Docket No. SA-534

CPUC SEPTEMBER 24, 2010 LETTER TO PG&E REGARDING GO 112E AUDIT OF PG&E PENNINSULA DIVISION

SUBJECT: General Order 112-E Audit of PG&E's Peninsula Division

State of California – Public Utilities Commission General Order 112-E Inspection – Peninsula Division

District Regulator Station Maintenance Record

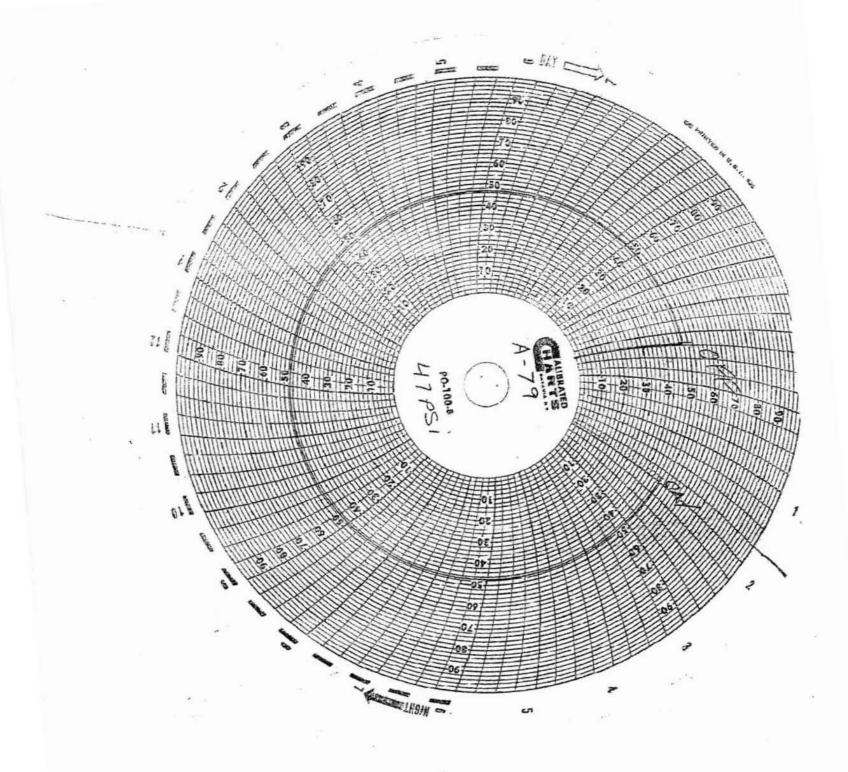
During the field inspection at regulator station A-79, the monitor did not take over. The
inspection of the regulator station was stopped prior to the downstream pressure exceeding
MAOP + allowable. The monitor was then reset at a lower pressure and it then took over.
Please ensure that regulator station devices are set to the appropriate set points in order to
protect against over pressuring.

For the record, the monitor set point for Regulator Station A-79 was appropriate at the time of the USRB audit (52 psig). However, as you note, during the audit, the monitor did not take over and the monitor was reset at a lower pressure (47 psig).

Subsequently, an internal inspection of the regulator station was performed on July 22, 2008. (See attached documentation.) A full class "B" maintenance inspection was performed. The monitor was torn down, all rubber goods were replaced, monitor was cleaned, reassembled and reinstalled. No problems were observed during the inspection. The monitor regulator was tested and observed to control at 52 psig at the completion of the inspection.

We have inspected and maintained the monitor to ensure proper operation. (See Attachment E – Regulator Station A-79 Maintenance Record.)

Date	Comments
7/22/08	FOUND MONITOR AT 32051. PERFORMANCE WAS
	GOOD. PERFORMED "B" MAINT ON MONITOR REG 9
	CONTROL LOOP, PER GALES, RETURNED STAT
************	FOUND MONITOR AT 32 psi. PERFORMANCE WAS GOOD. PERFORMED "B" MAINT ON MONITOR REG 9 CONTROL LOOP, PER GALE S., RETURNED STAT TO NORMAN OPERATION.
	,
